Carmichael Coal Mine and
Rail Project SEIS
Volume 3 Rail Studies

5 November 2013

Figure 1
Page 1 of 4

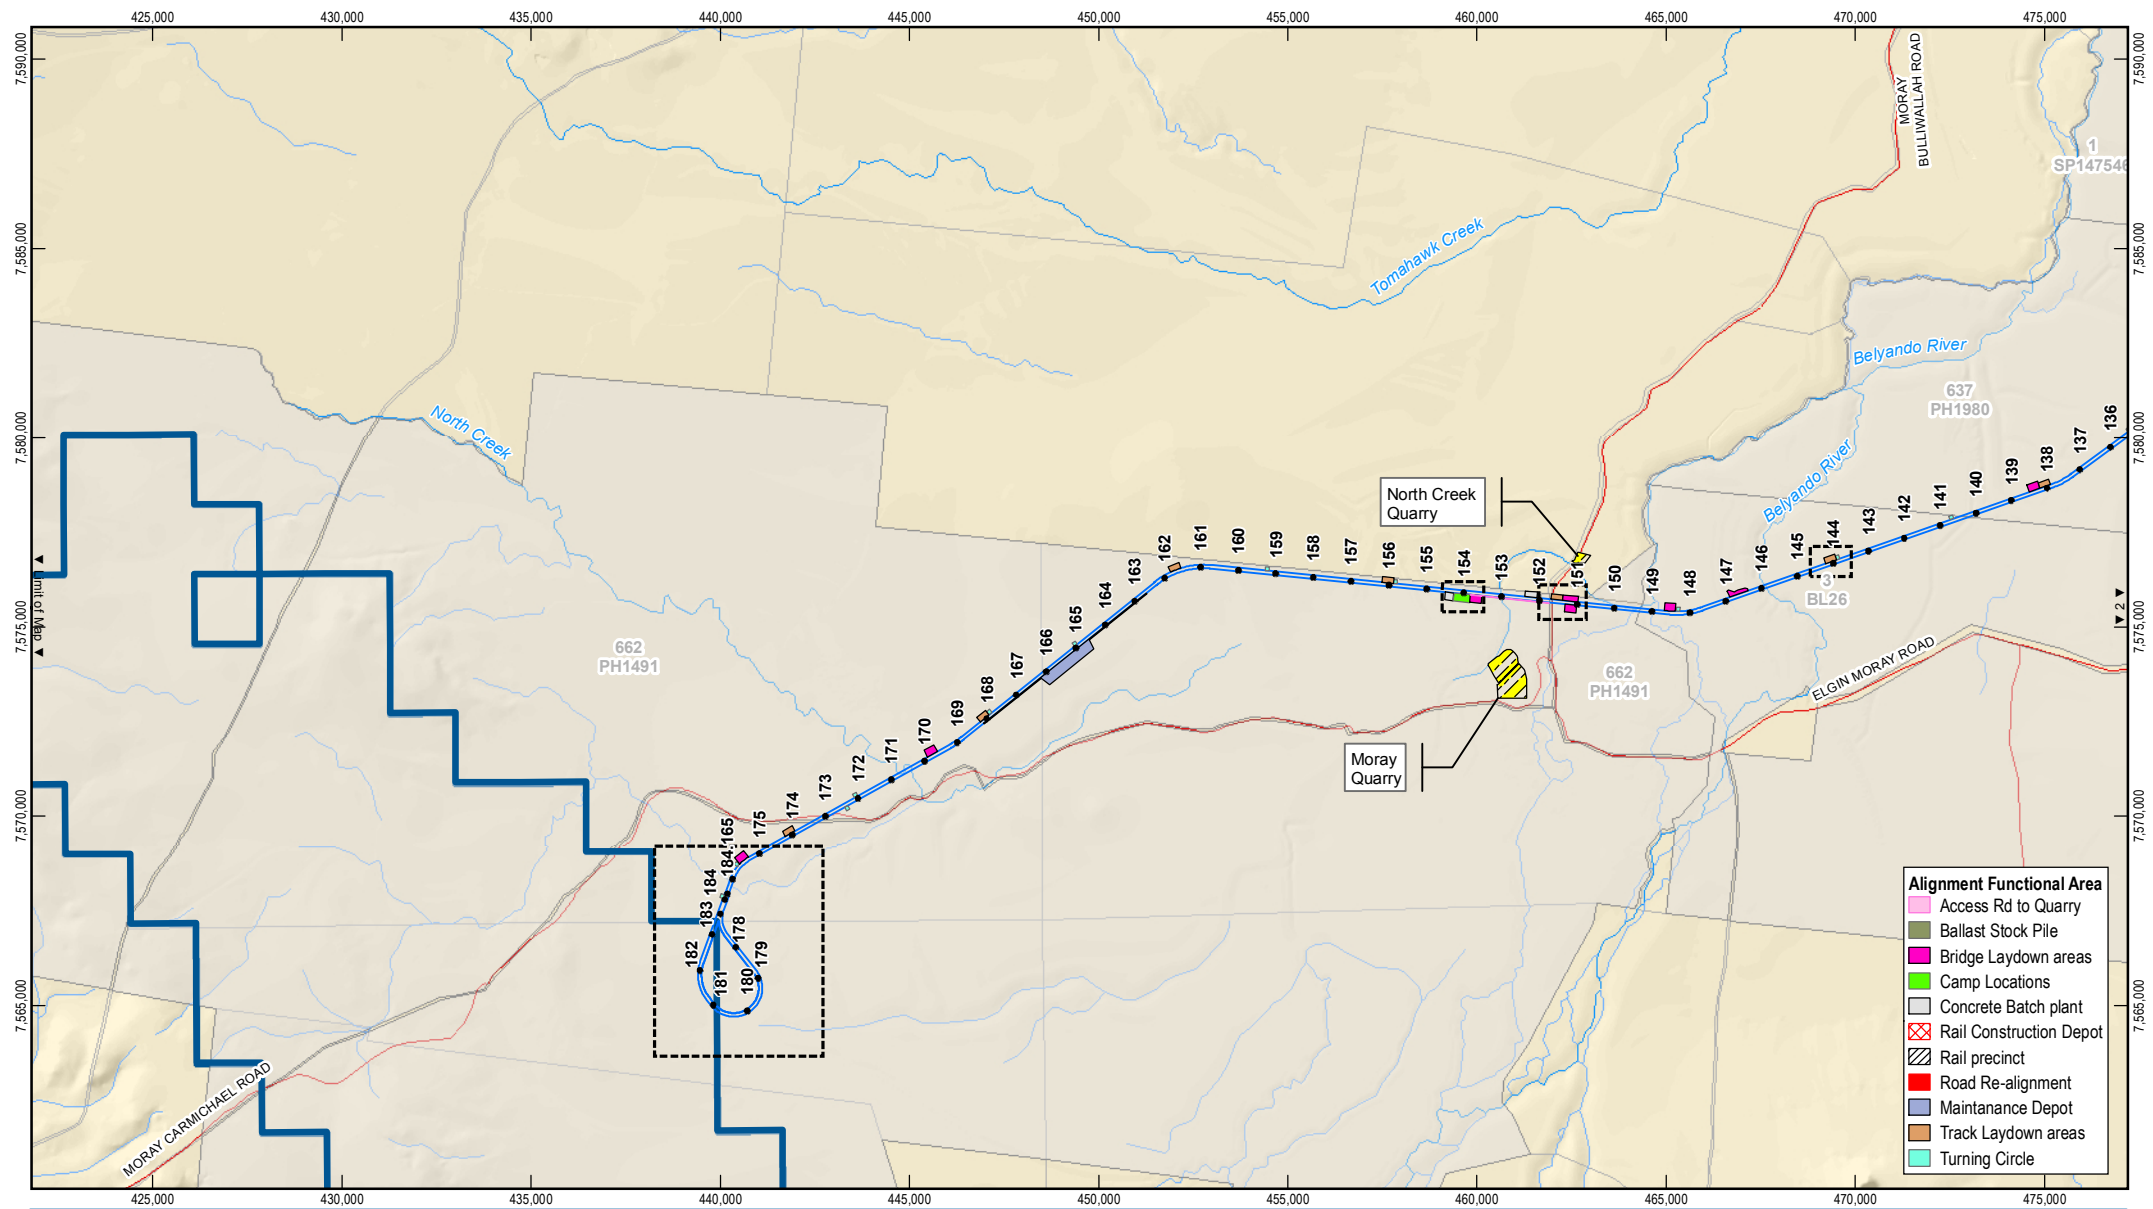
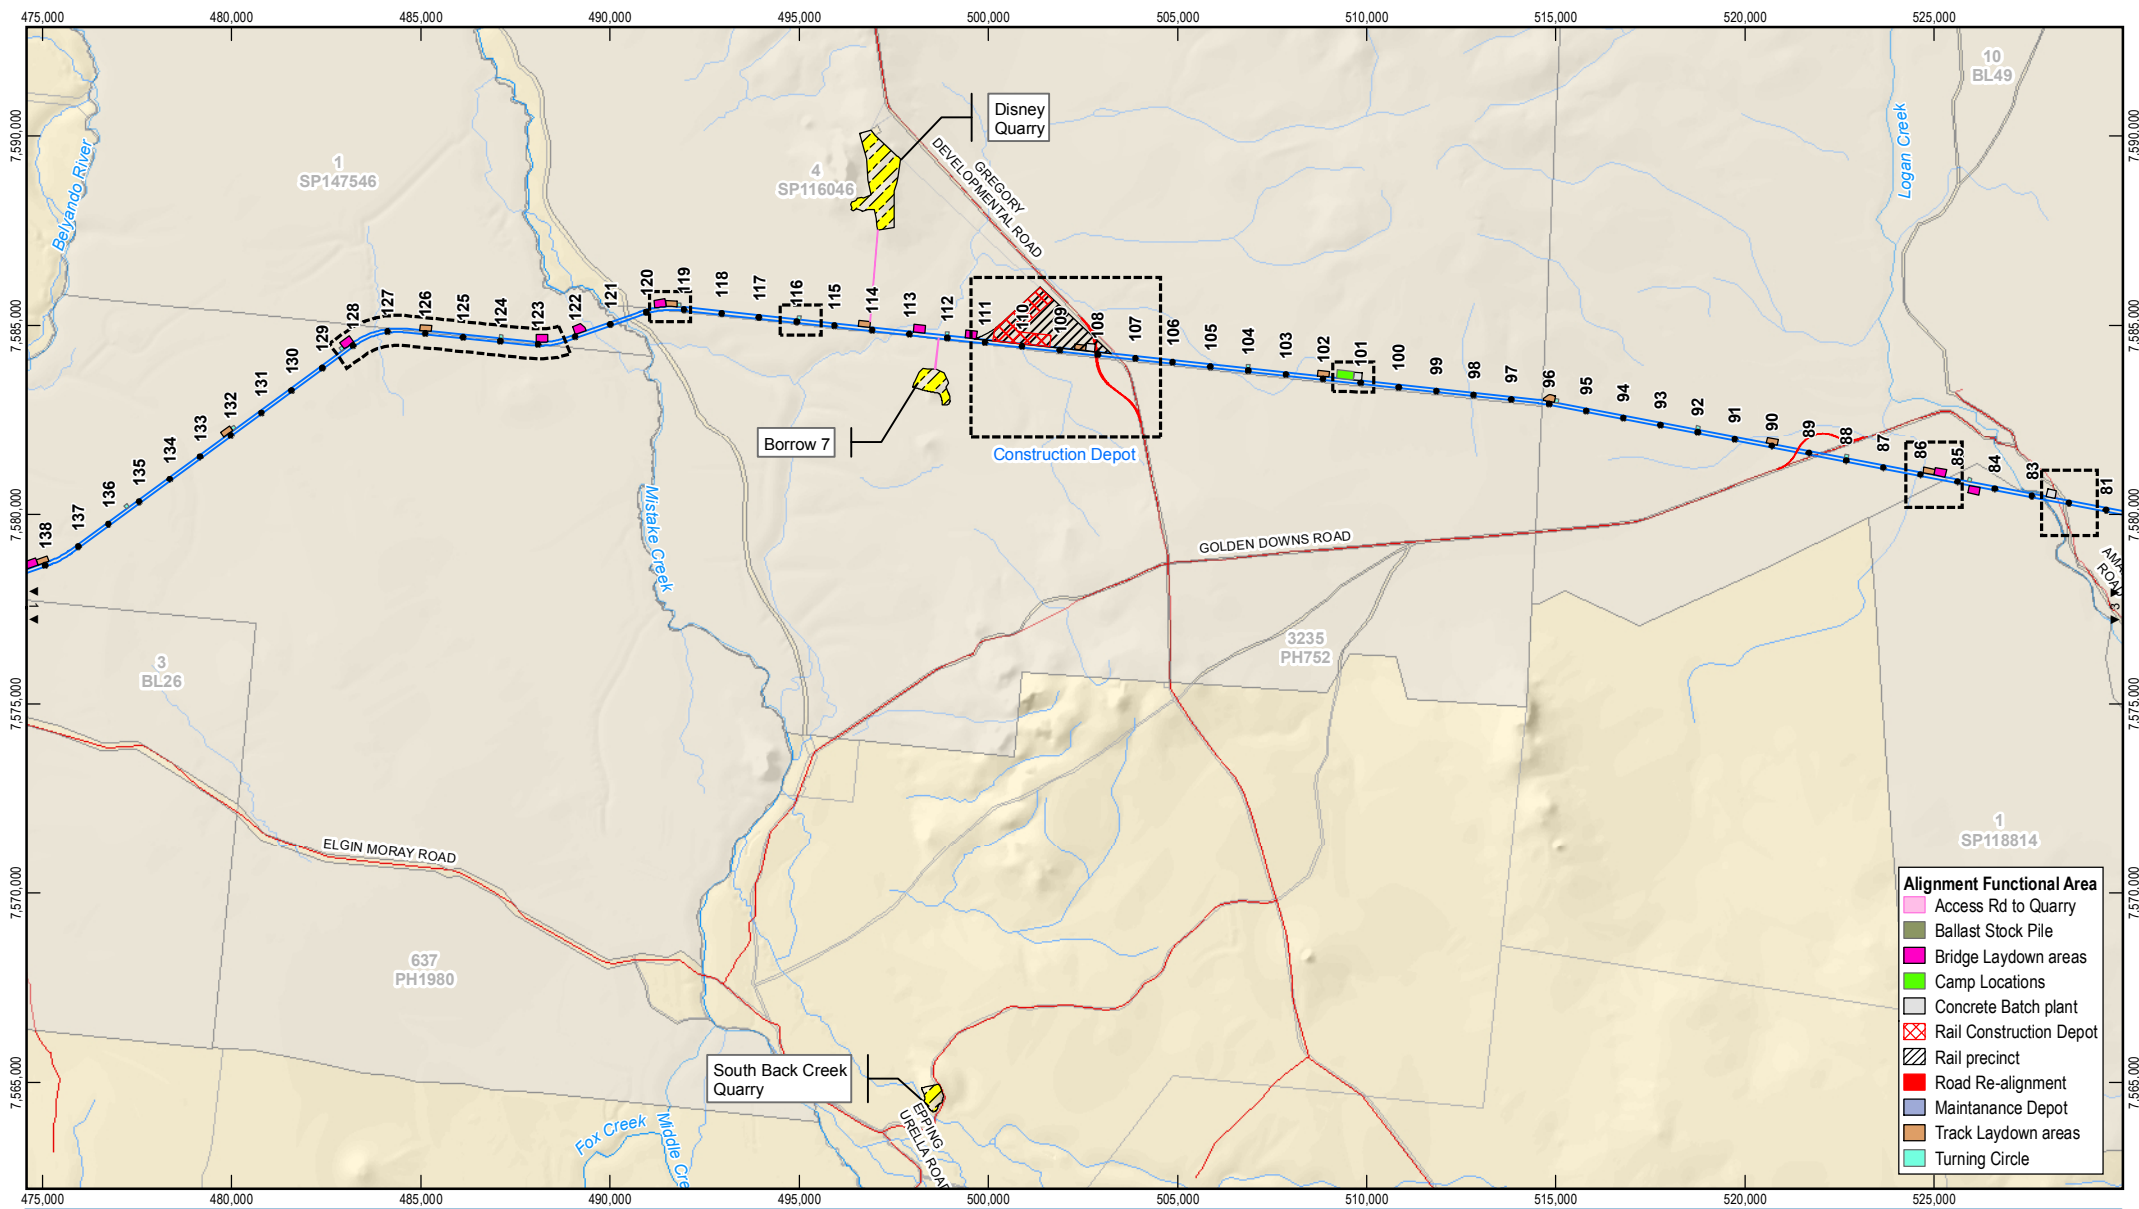
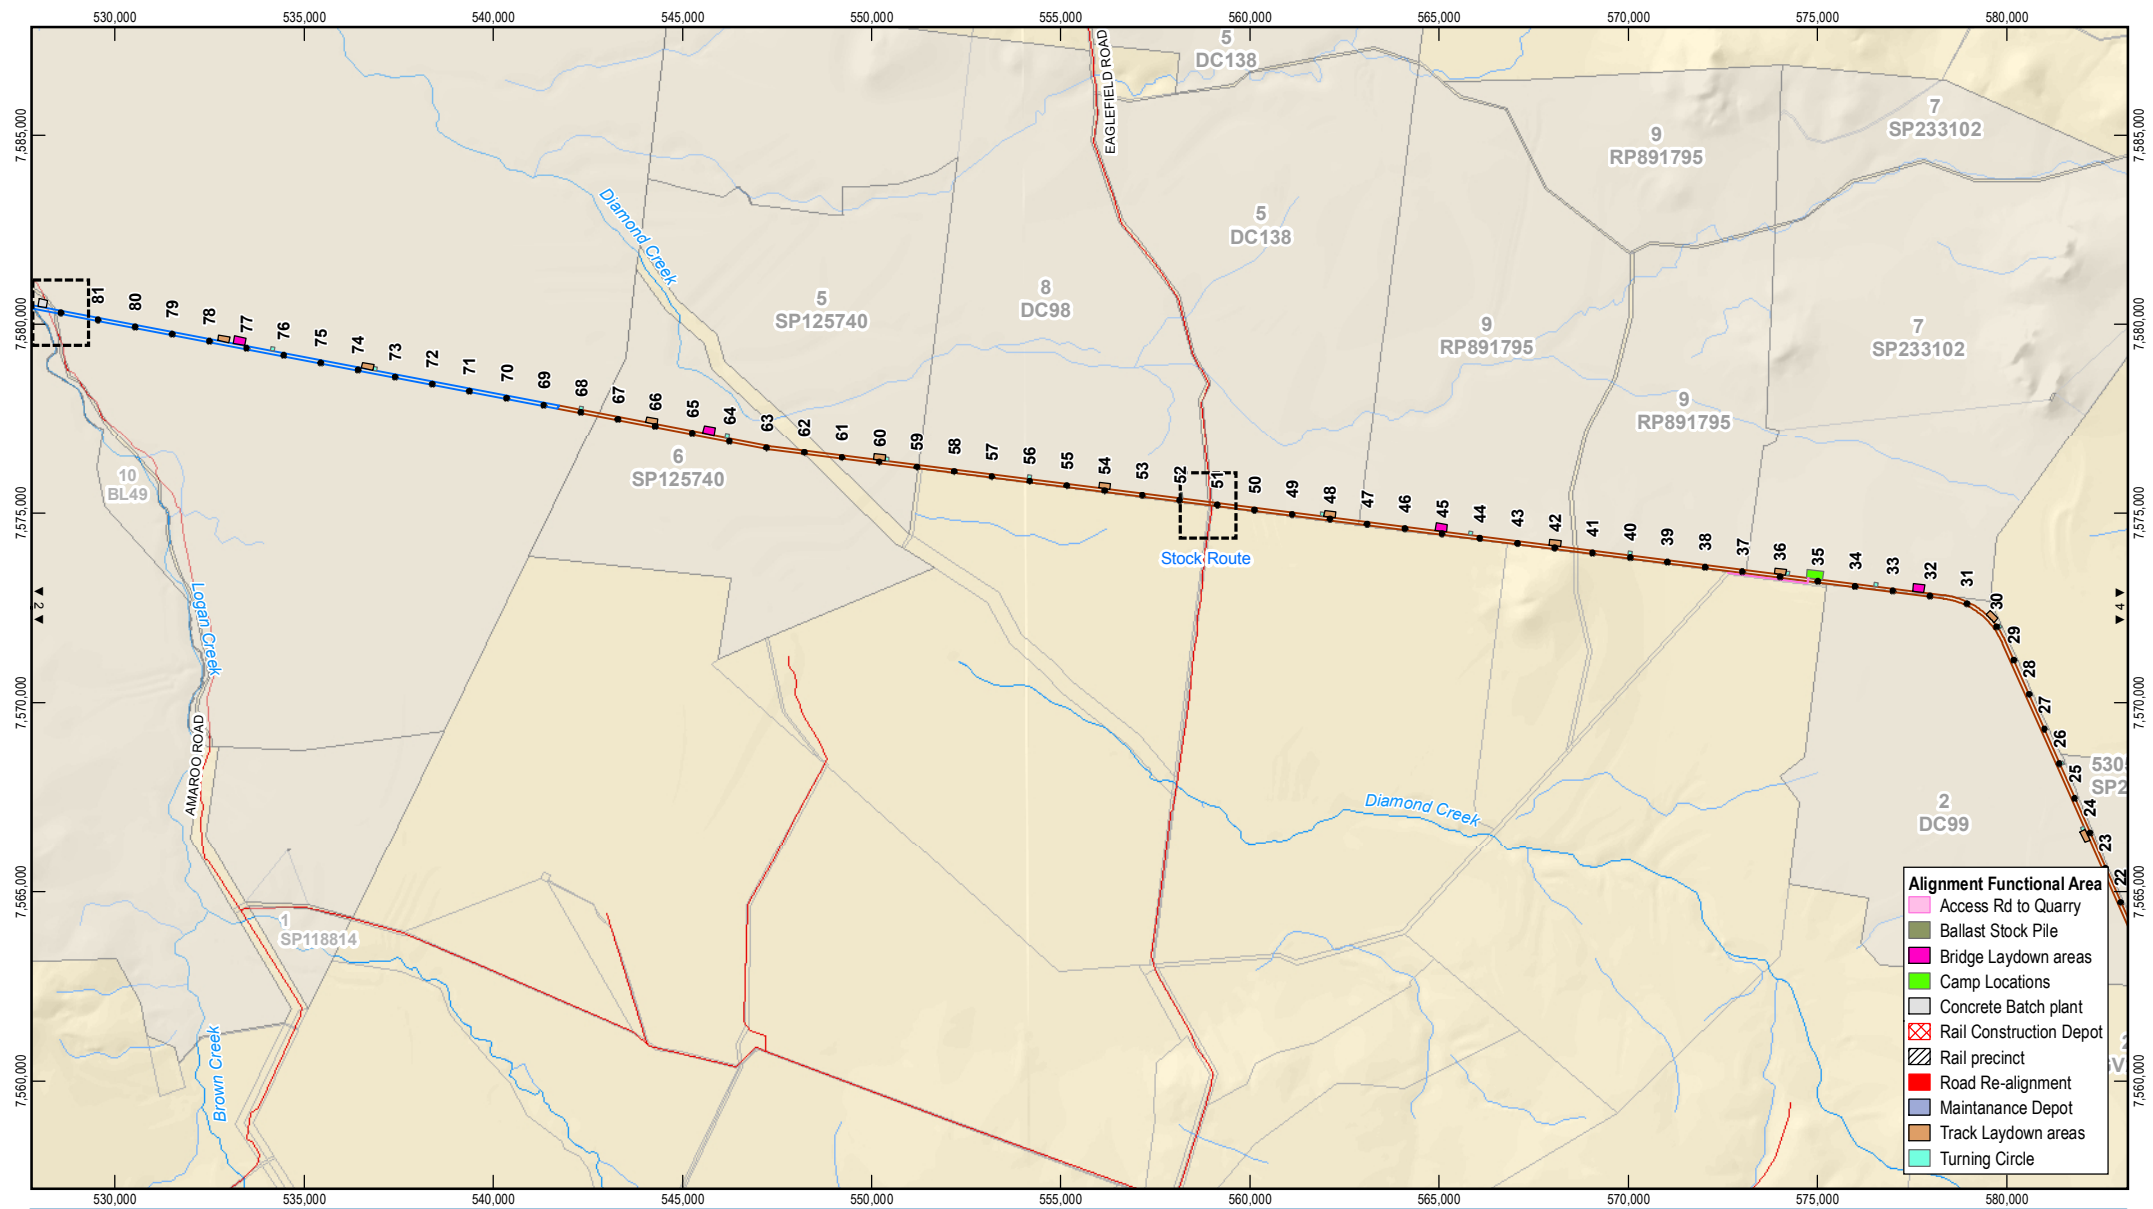
The following sections highlight amendments to the initial Project (Rail) description that have occurred in the SEIS phase of the Project (Rail). All amendments have been identified in Figure 1.

The rail balloon loop located on Lot 662 PH1491 has been realigned approximately 2 km to the south east (from Eight Mile Creek) following a review of the mine product stockpile configurations and coal handling plant. As part of the realignment, the following associated rail infrastructure was realigned:

- Concrete batching plant at Chainage 182.500 in the EIS was removed
- Bridge laydown at Chainage 175.500 was reorientated 50 m south
- Turning circle (Chainage 176.000) was moved 400 m east to be adjacent to the bridge laydown areas
- Turning circle (Chainage 175.400) was moved 375 m south east onto the stem of the new loop
